<b>DART AEROSPACE LTD</b>	<b>Work Order:</b>	109152
<b>Description:</b> Crosstube Assembly (412 Low Narrow Fwd)	<b>Part Number:</b>	D412-664-145
<b>Inspection Dwg:</b> D412-664-145 <b>Rev:</b> D		<b>Page 1 of 2</b>

DRAWING NO. D412-664-145	TITLE CROSSTUBE ASS'Y (412 LOW-N FWD)	REV. D	<b>DART AEROSPACE LTD ENGINEERING ORDER</b>		D.E.O. NO. D412-664-145-D-1	SHEET NO. SHEET 1 OF 2	SCALE NTS
DRAWN <i>q</i>	CHECKED <i>sc</i>	MFG. APPR. <i>E</i>	APPROVED <i>MD</i>		DE APPR. <i>#</i>		
DATE 11.05.25	DATE 11.05.31	DATE 11.05.31	DATE 11/25/31		DATE 11.05.31

DRAWING NO. D412-664-145	TITLE CROSSTUBE ASS'Y (412 LOW-N FWD)	REV. D	DART AEROSPACE LTD ENGINEERING ORDER		D.E.O. NO. D412-664-145-D-2	SHEET NO. SHEET 1 OF 1	SCALE NTS
DRAWN qp	CHECKED ASS	MFG. APPR. RB	APPROVED JMP		DE APPR. #		
DATE 11.07.15	DATE 11.07.20	DATE 11-07-21	DATE 11/07/21		DATE 11.07.21

DRAWING NO. D412-664-145	TITLE CROSSTUBE ASS'Y (412 LOW IN FWD)	REV. D	<b>DART AEROSPACE LTD ENGINEERING ORDER</b>		D.E.O. NO. D412-664-145-D-3	SHEET NO. SHEET 1 OF 3	SCALE NTS
DRAWN 97	CHECKED 6	MFG. APPR. 1	APPROVED [Signature]		DE APPR. [Signature]		
DATE 12.08.21	DATE 12.06.30	DATE 12.08.30	DATE 12/8/30		DATE 12.08.30

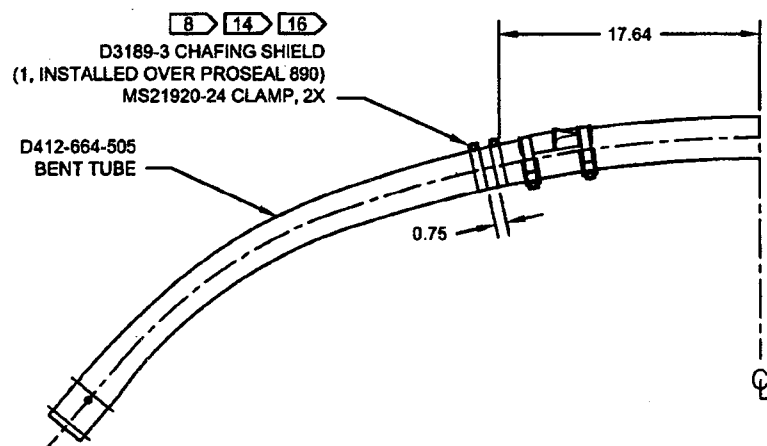
REMOVED ABRASION STRIP IN FAVOR OF A THIN LAYER OF PROSEAL 890.

- 14) APPLY A THIN COAT OF PROSEAL 890 ON INSIDE CONCAVE SURFACE OF D3189-3 CHAFING SHIELD AND LET CURE PER MANUFACTURER'S INSTRUCTIONS. INSTALL PROSEALED D3189-3 CHAFING SHIELD ONTO CROSSTUBE BY APPLYING A THIN COAT OF PROSEAL 890 ONTO CROSSTUBE. BE SURE TO ELIMINATE ANY AIR GAPS.

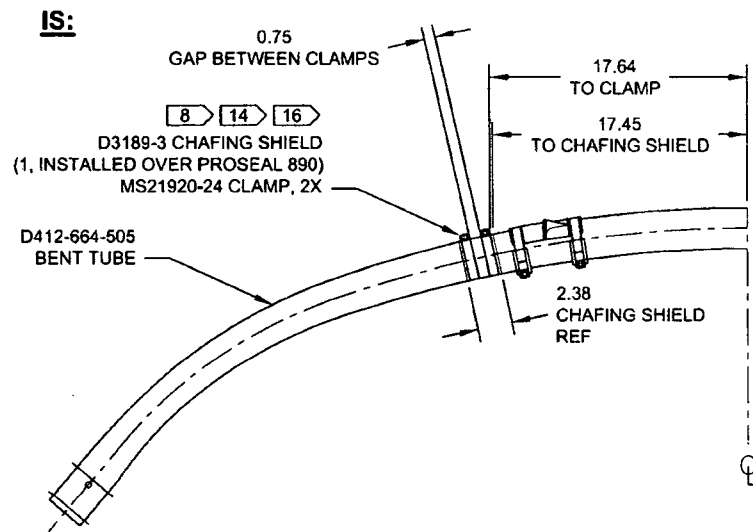
REMOVED ABRASION STRIP IN FAVOR OF A THIN LAYER OF PROSEAL 890. UPDATE INSTALLATION OF CHAFING SHIELDS AND REDUCE TORQUE TO 40-50 IN-LBS. THIS ENGINEERING ORDER SUPERCEDES DEO D412-664-145-D-1.

- 14) APPLY A THIN COAT OF PROSEAL 890 ON INSIDE CONCAVE SURFACE OF D3189-3 CHAFING SHIELD AND LET CURE PER MANUFACTURER'S INSTRUCTIONS. INSTALL PROSEALED D3189-3 CHAFING SHIELD ONTO CROSSTUBE BY APPLYING A THIN COAT OF PROSEAL 890 ONTO CROSSTUBE. BE SURE TO ELIMINATE ANY AIR GAPS.
- 16) TORQUE CLAMPS ON D2893-1 SUPPORT 80 TO 100 IN-LB. **TORQUE CLAMPS ON D3189-3 CHAFING SHIELD 40 TO 50 IN-LB.** ENSURE AT LEAST 1.5 THREADS SHOWING IN SAFETY AND THAT NUT HAS NOT BOTTOMED-OUT AFTER TORQUING.

**SECTION A-A**  
CHAFING SHIELD DETAIL  
VIEW ROTATED, NOT TO SCALE

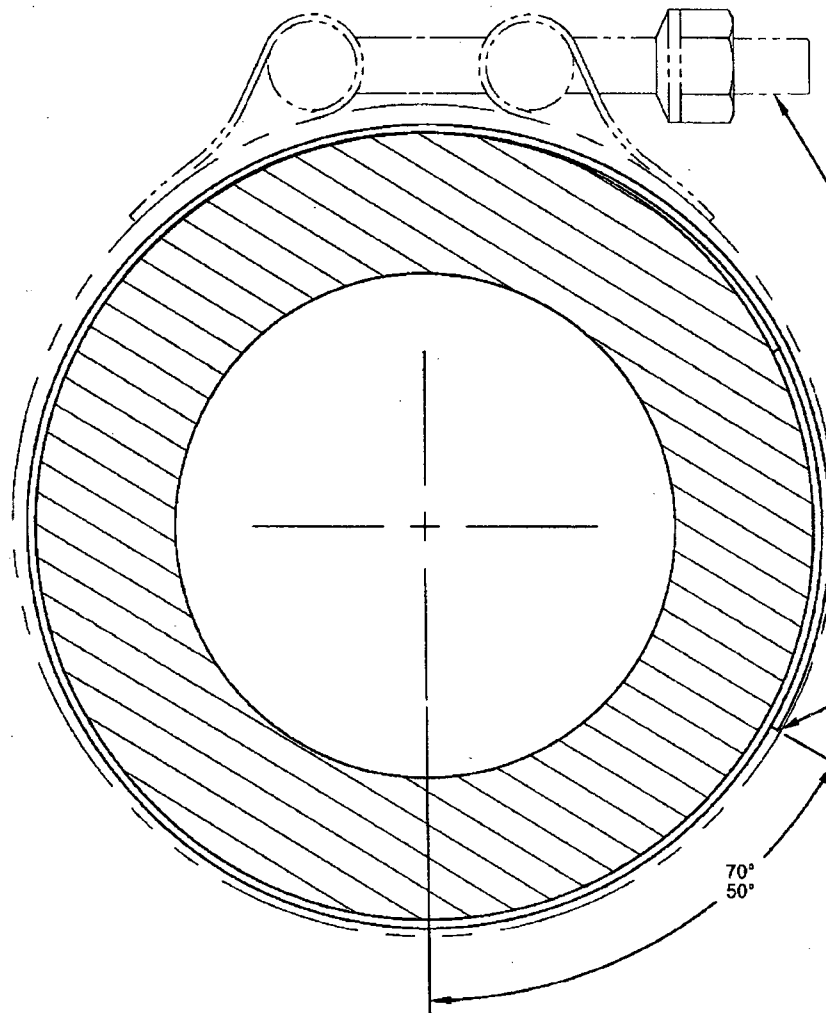
WRAP D3189-3 AROUND TUBE  
AND ORIENT OVERLAP AS SHOWN
